**TOWN OF MOUNTAIN VILLAGE
REGULAR DESIGN REVIEW BOARD MEETING AGENDA
THURSDAY MARCH 30, 2023 10:00 AM
MOUNTAIN VILLAGE TOWN HALL
455 MOUNTAIN VILLAGE BLVD, MOUNTAIN VILLAGE, COLORADO
TO BE HELD HYBRID THROUGH ZOOM:**

**DESIGN REVIEW BOARD MINUTES
TOWN OF MOUNTAIN VILLAGE
REGULAR DESIGN REVIEW BOARD MEETING
MARCH 2, 2023**

SHEET NO.
A-1.2

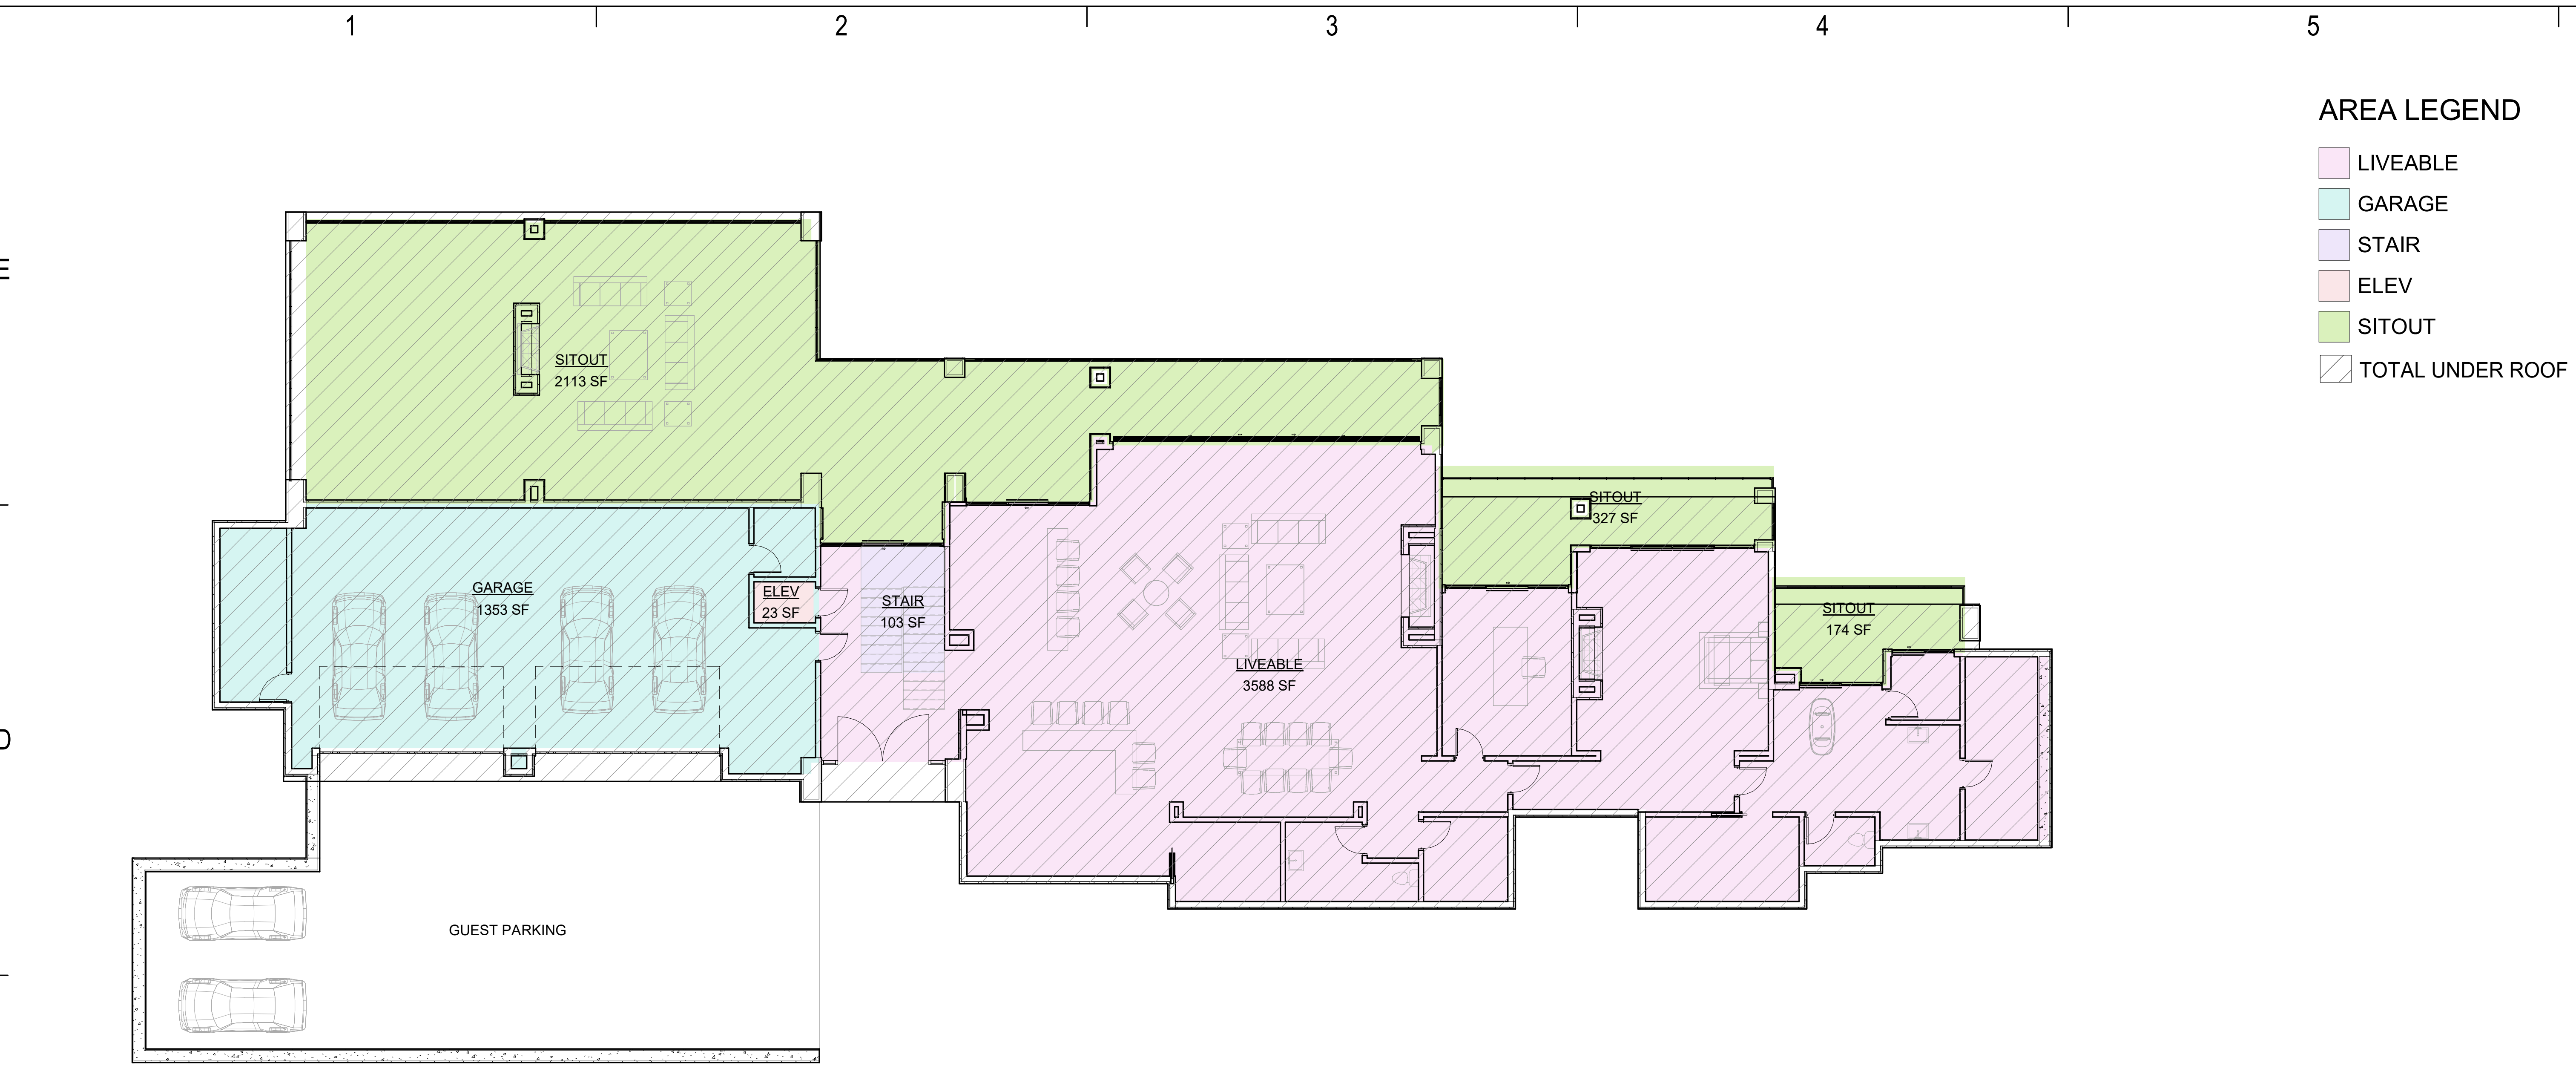
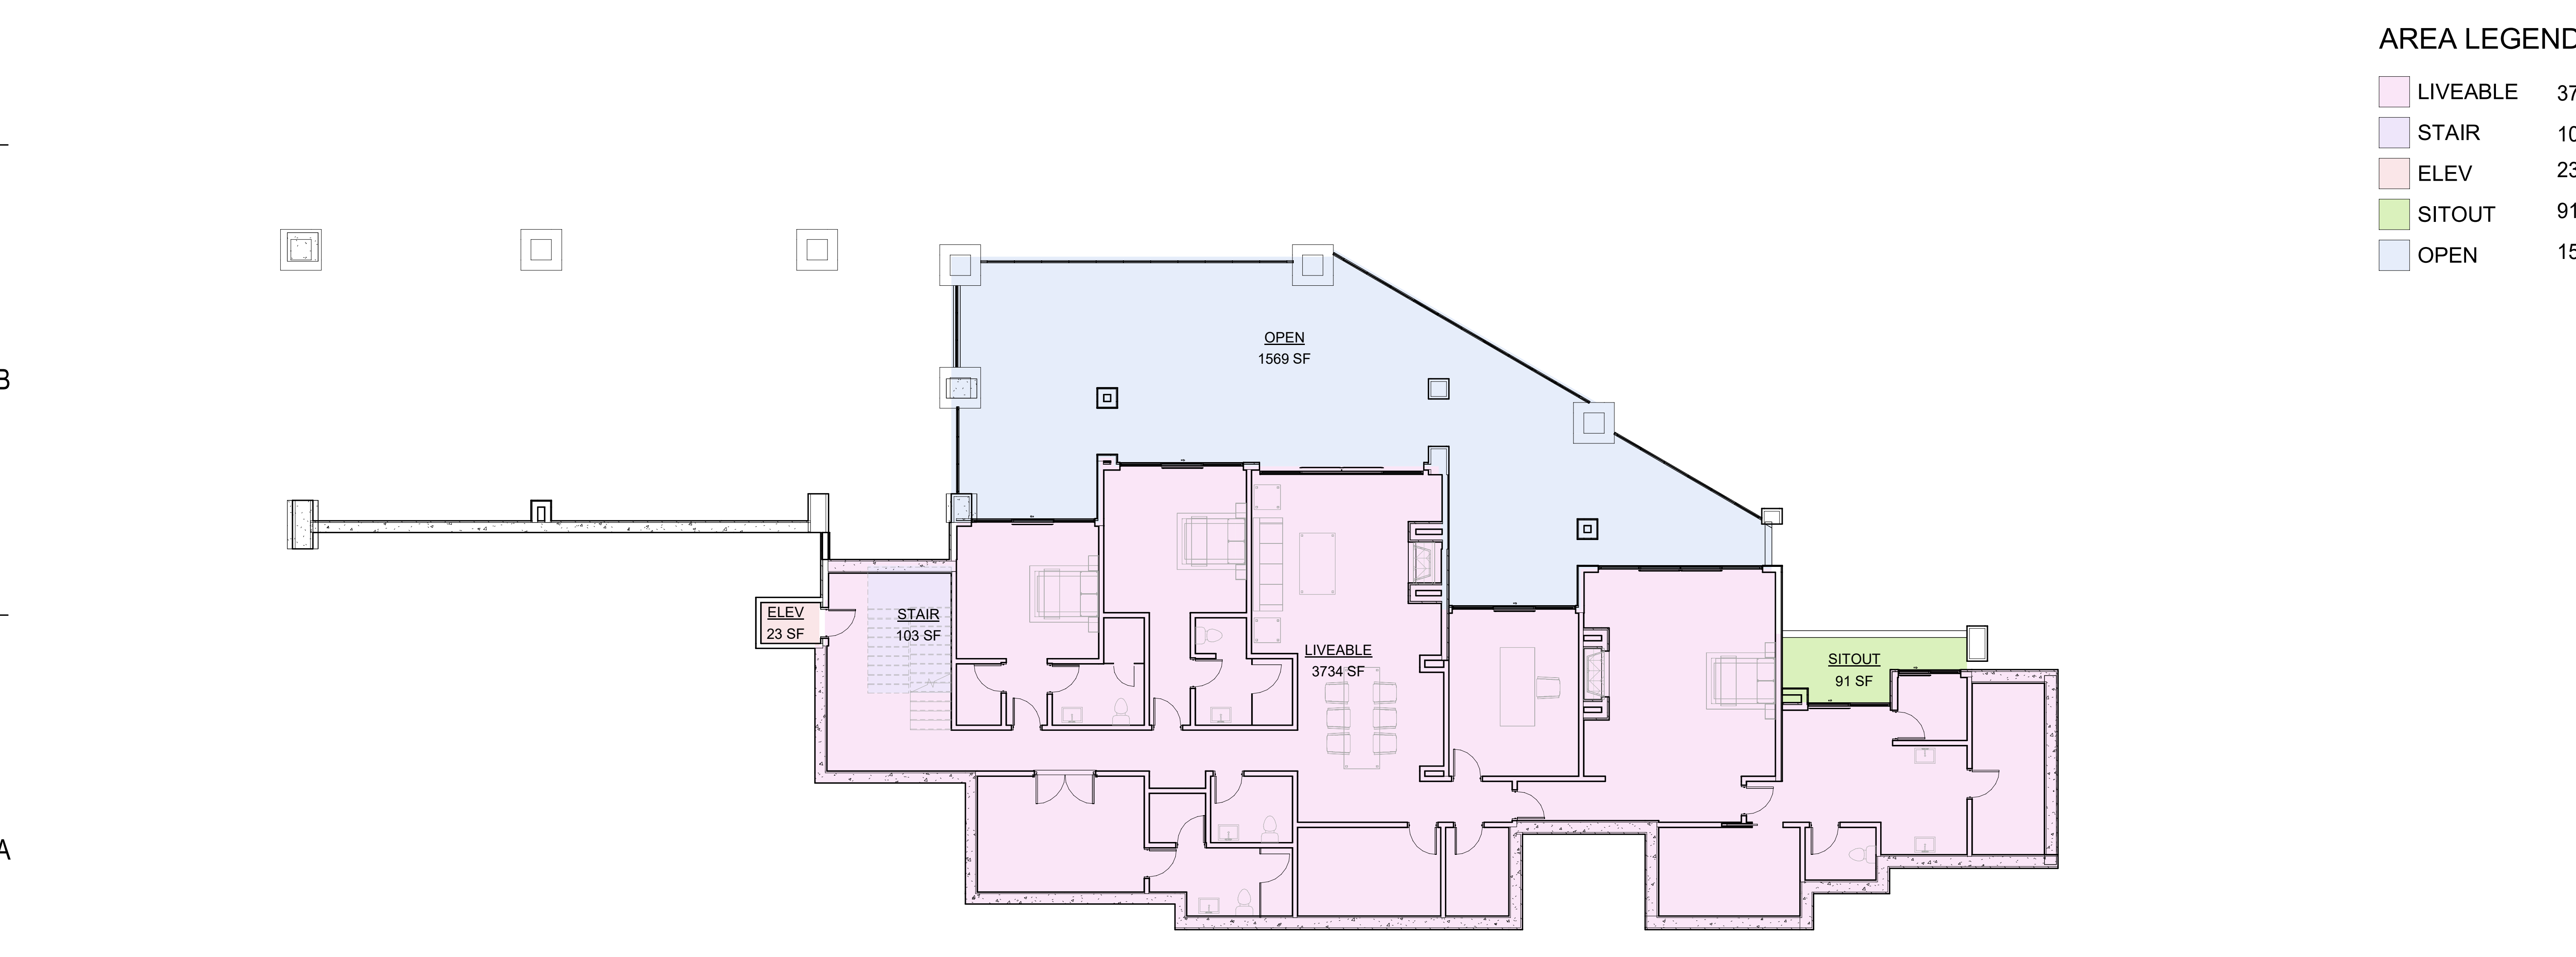
Staff: Staff has determined prior to initial review that the primary roof form for this home is a shed and therefore granted a maximum height of 35' and an average height of 30'. According to Sheet A1.2 of Exhibit A, the applicant has calculated a maximum height of 35' and an average height of 27.1'.
